Revised Plan of South Abutment

DRY RIFFLE RUN BRIDGE

CONCRETE BEAM BRIDGE

MUSKINGUM COUNTY

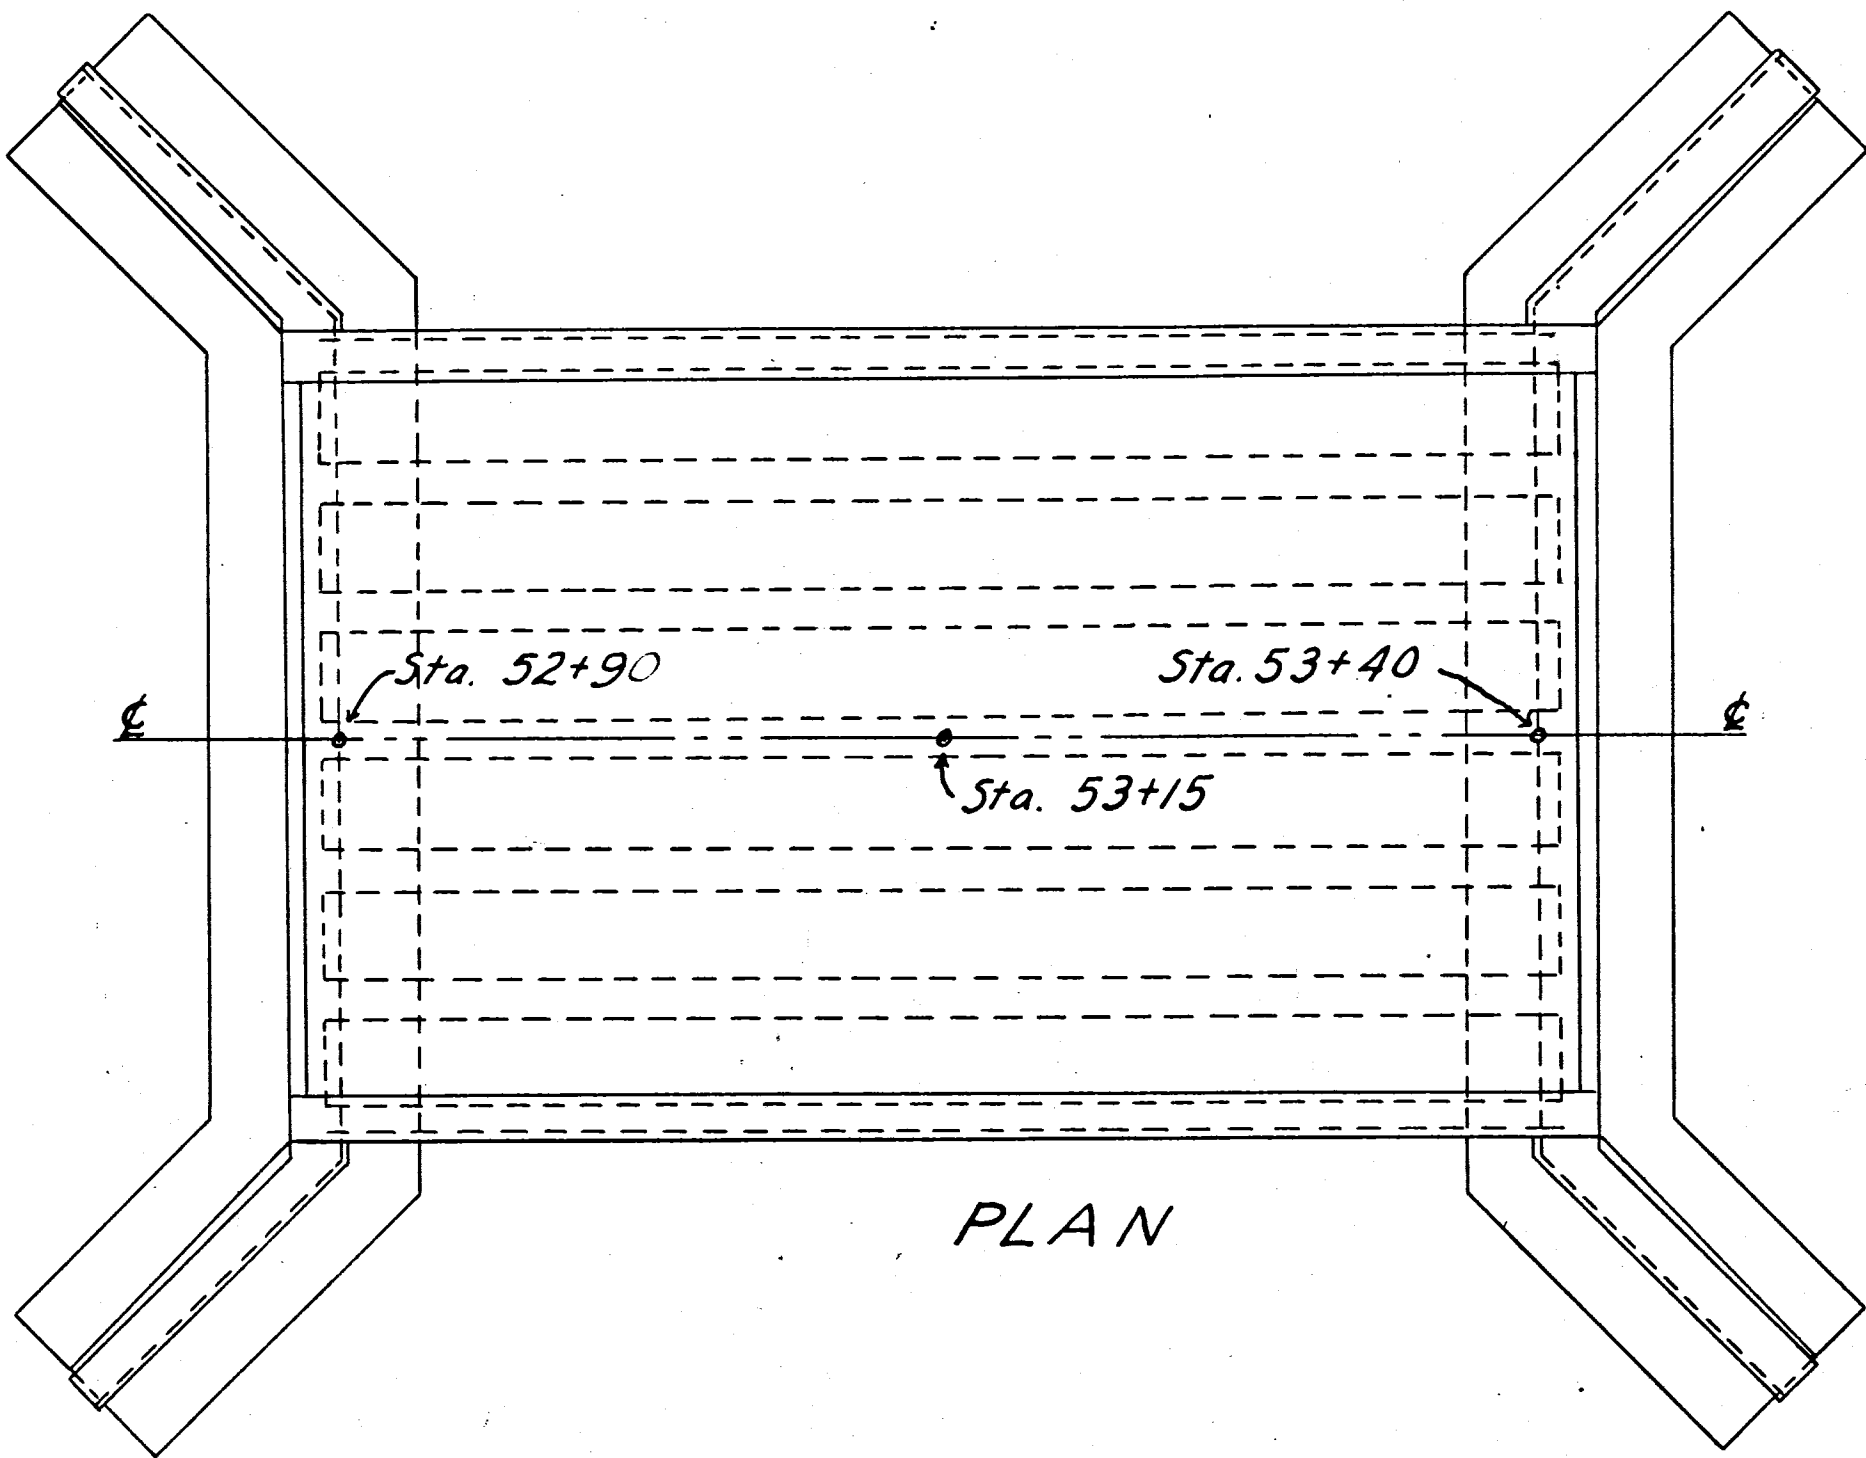
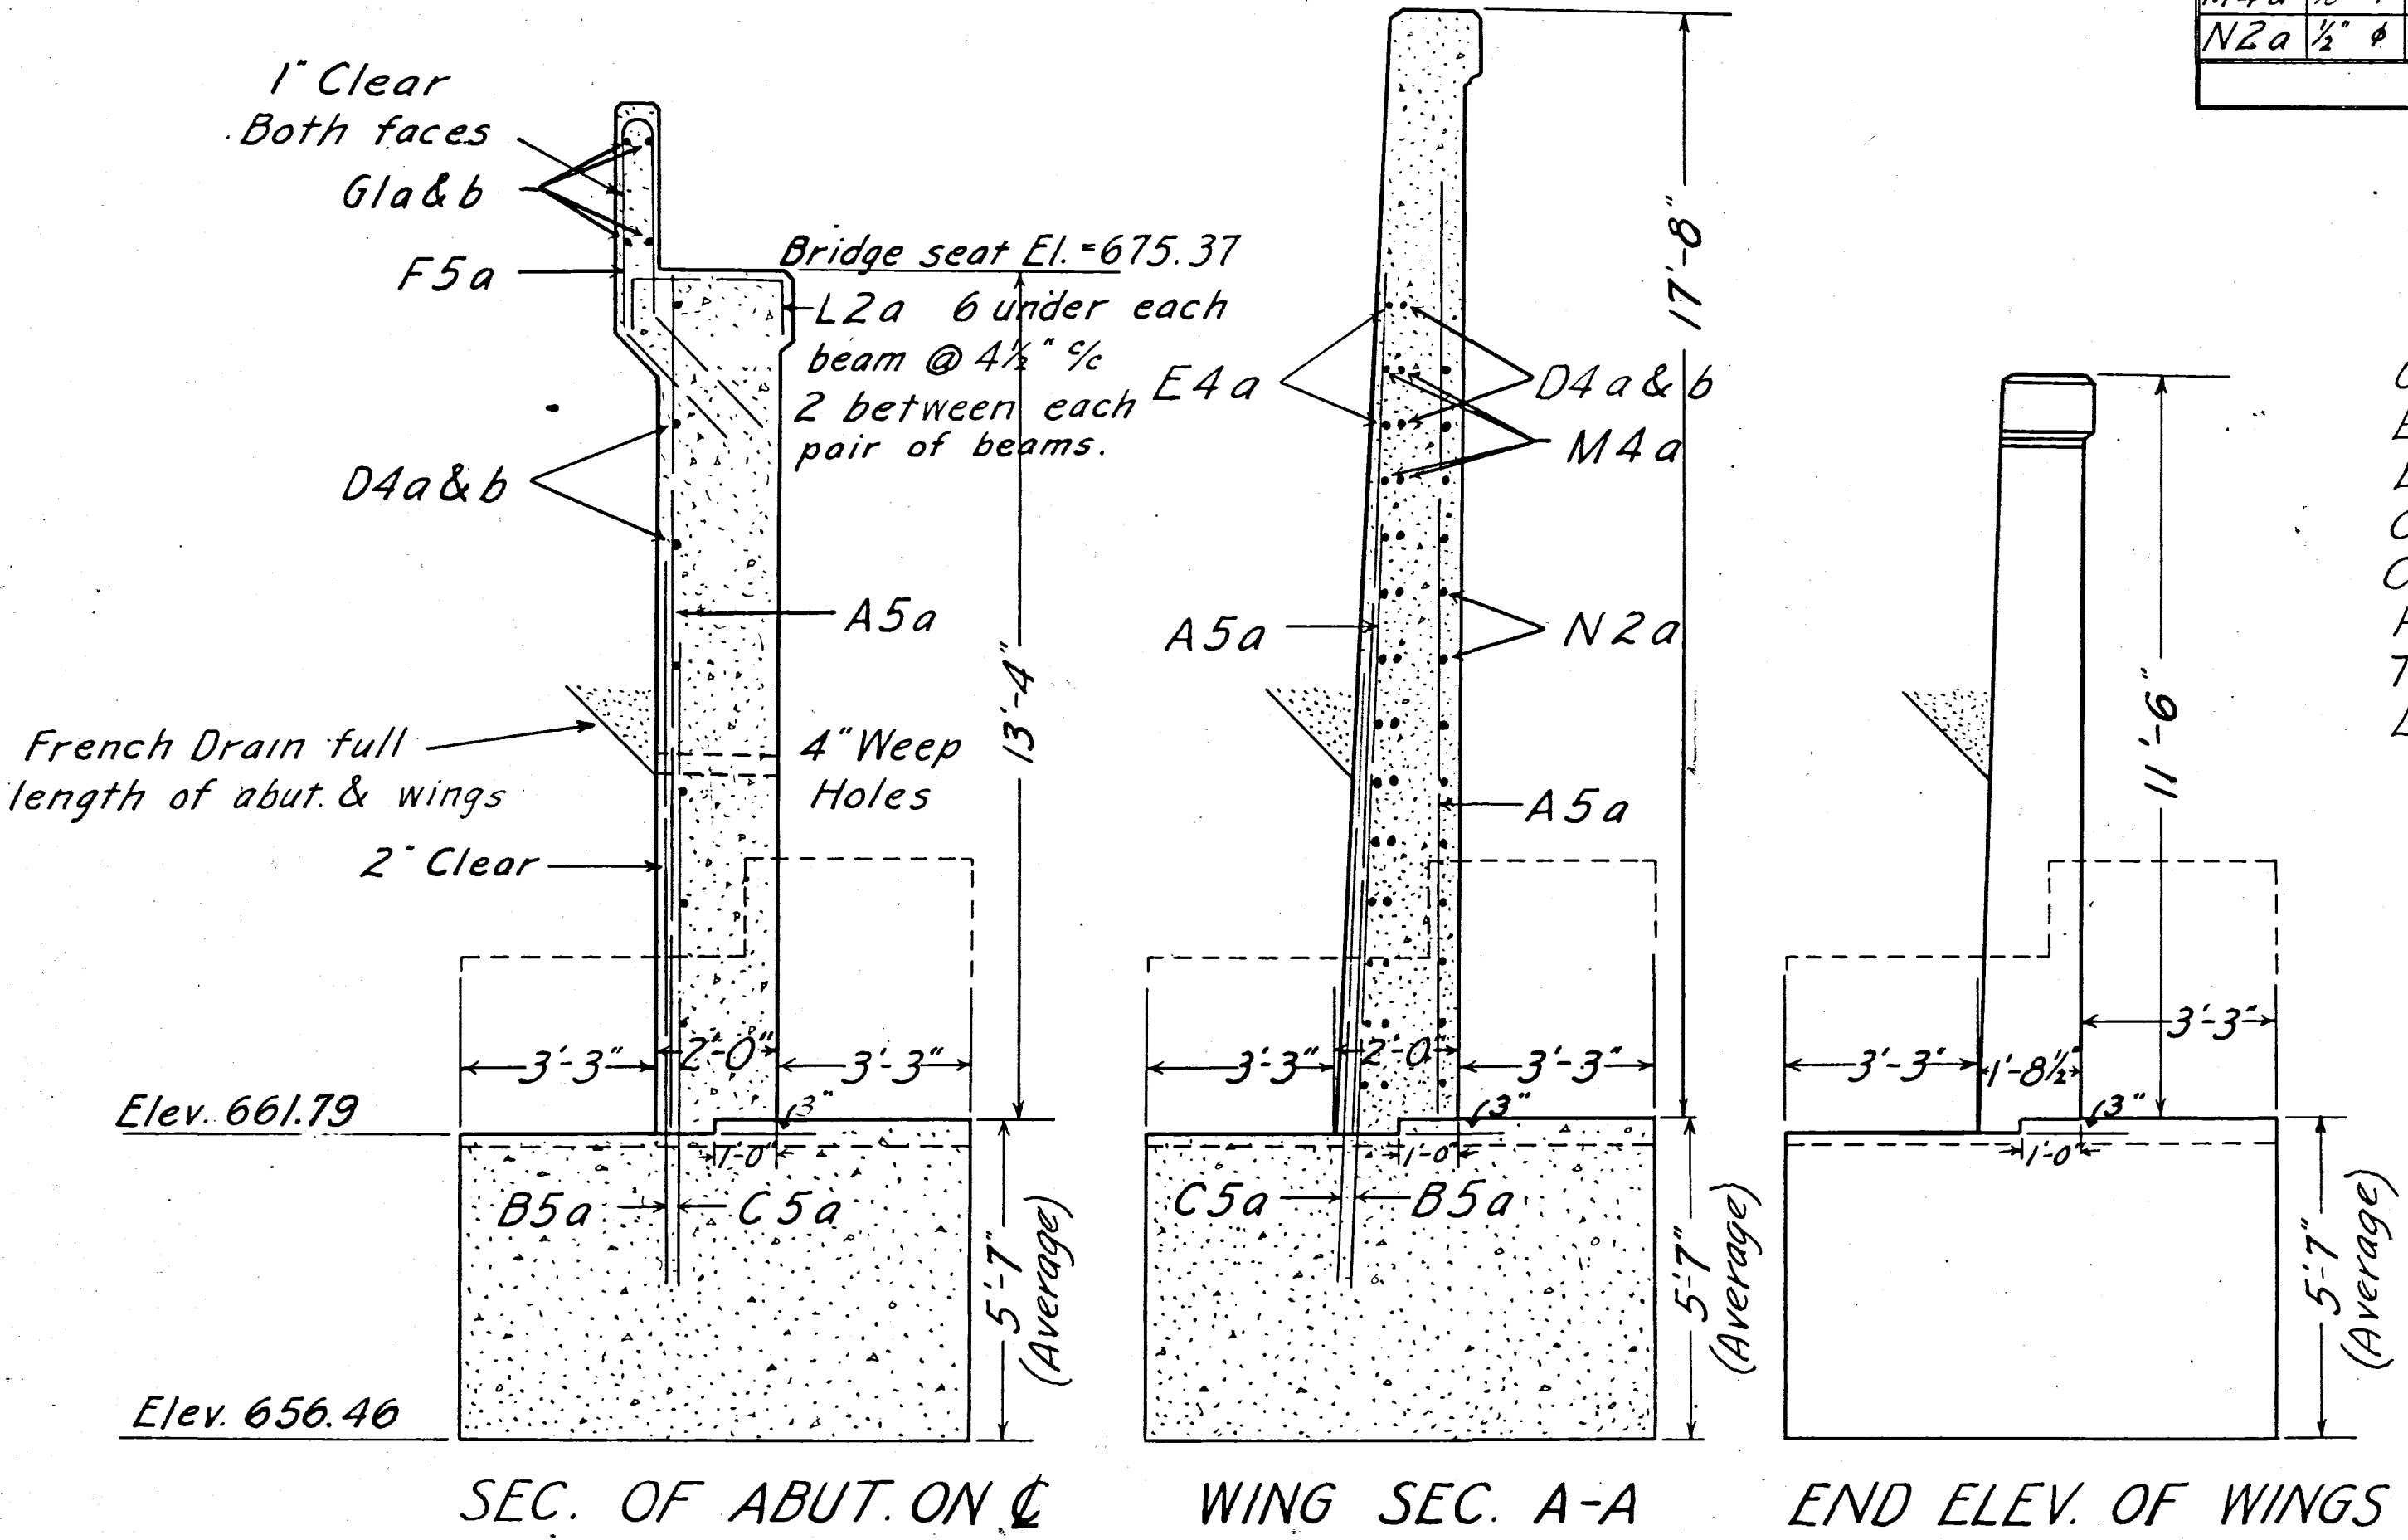
This sheet is supplementary to sheet No 14 of the original plans. The north abutment was built according to the original plans. The south abutment was built as shown on this sheet; the design was changed because rock was encountered at approx. Elev. 658.0, thus making it impossible to drive piles and making it necessary to deepen the footing. Approx. 40 Cu.Yds. of loose and irregular rock were removed to obtain a firm and even foundation.

Note: Broken line shows footer as originally planned.

REVISED PLAN	QUANTITIES
Exc. rock	40 Cu.Yds. (New Item)
Exc. wet	336
Conc. 1-6 1/2' (footing)	183.4
Conc. 1-6 1/2' (walls)	116.1
Reinf Steel	8271 lbs.
Lump-Cofferdam & pumping	\$200.00 (Additional)
Exc. Dry	360 Cu.Yds.
Deduction from original quantities 1430 lin.ft. of piling.
